RECEIPT DATE: 4/27/16 **ONSITE SEWAGE DISPOSAL SYSTEM** P 558100
 APPROVAL DATE: 6/19/16 **PERMIT: CONSTRUCTION** A _____
 PROPERTY ADDRESS: 1836 Florence Road
 SUBDIVISION: Kogan Trust LOT: 18 TAX ID: 05-595461
 CONTRACTOR: South Carroll Backhoe EMAIL: scbackhoe@comcast.net
 CONTRACTOR ADDRESS: 4410 Salem Bottom Road PHONE: 410-596-3618

SITE PLAN FOR BAT INSTALLATION

KOGAN TRUST - LOT 18
 1836 FLORENCE ROAD
 MT. AIRY, MD 21771

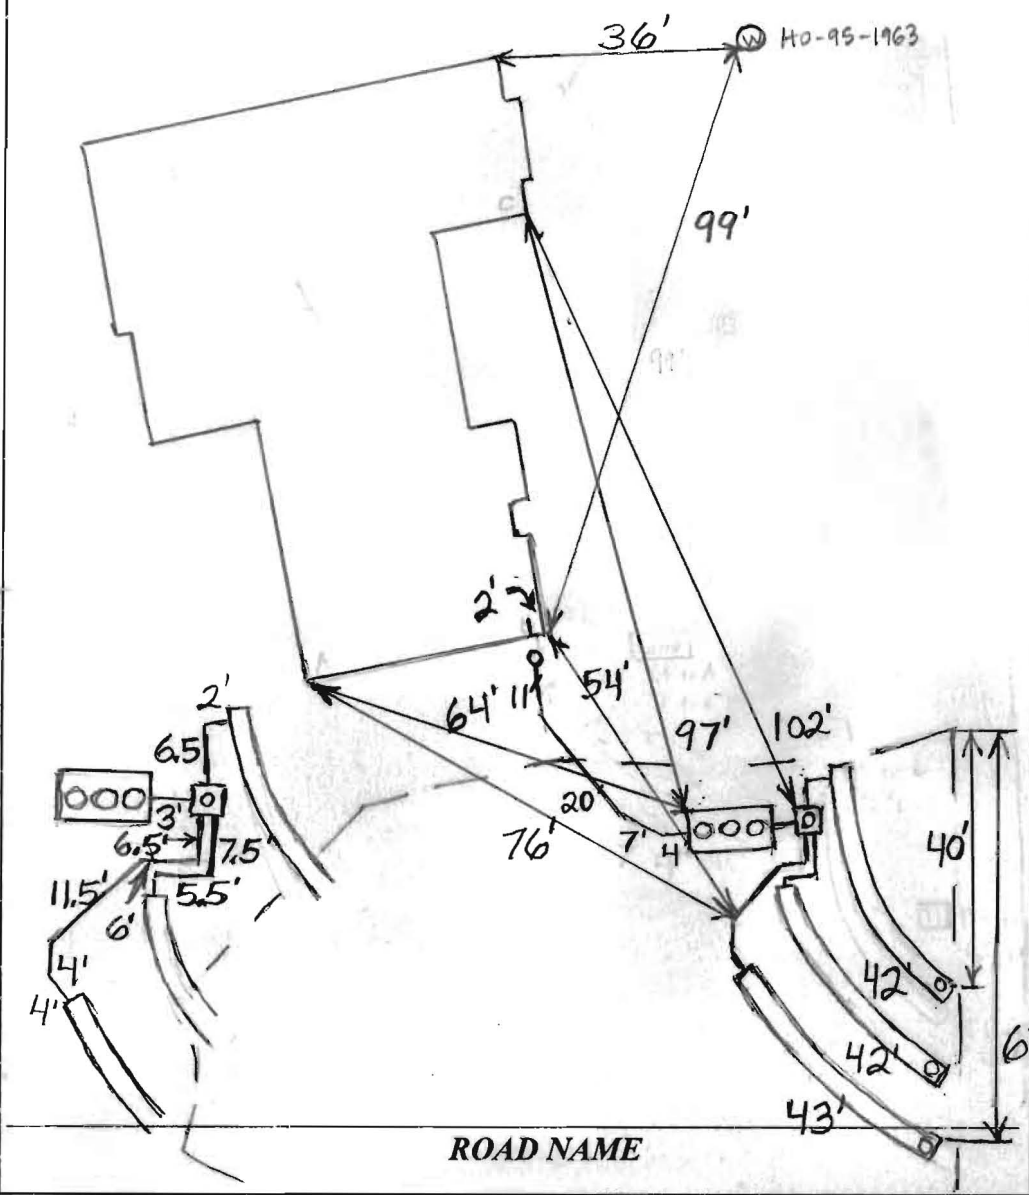
NOTES: Install 3x42' trenches on contour:

5/13/16 Met South Carroll on site for layout. All SDA + tank stakes present. Laid out 3 x 42' on contour in the eastern portion of the SDA. Some fill (few inches) in the northern part of the easement - South Carroll will scratch off prior to trench install and adjust trench starts to be on contour if necessary. (SC)

5/18/16 Tank set and house connection ^{not} made. S. Carroll digging TI. Only a couple of inches of fill were in part of SDA - trenches same as laid out. [4" pipe laid to house] Using transit while digging. Changed inlet to 3.5' b/c couldn't make fall to 3'. 2' wide, 8' to bottom. TI inlet is 3.9". (SC) 5/19/2016 System mostly complete. Need house connection and BAT certification from Norweco representative. (PB) 5/23/2016 Received BAT certification. (PB)

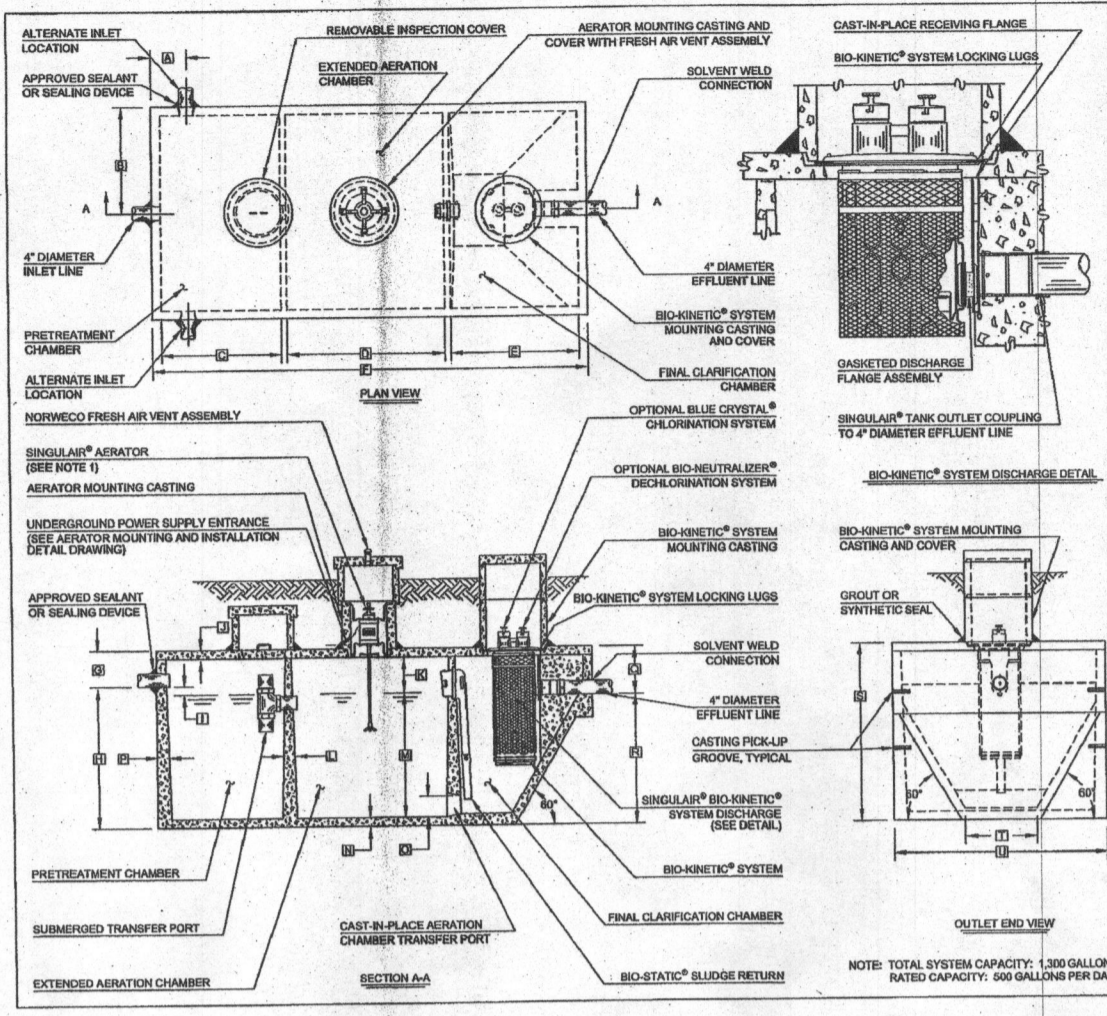
The building plan and the BAT plan does not match the percolation certification plan you submitted . I do not have the new percolation certification you are proposing. The latest version of your percolation certification plan located in our files is from 2010. On the BAT plan you must show the initial septic installment and the 2nd replacement installment. Do you have a copy of the new one?
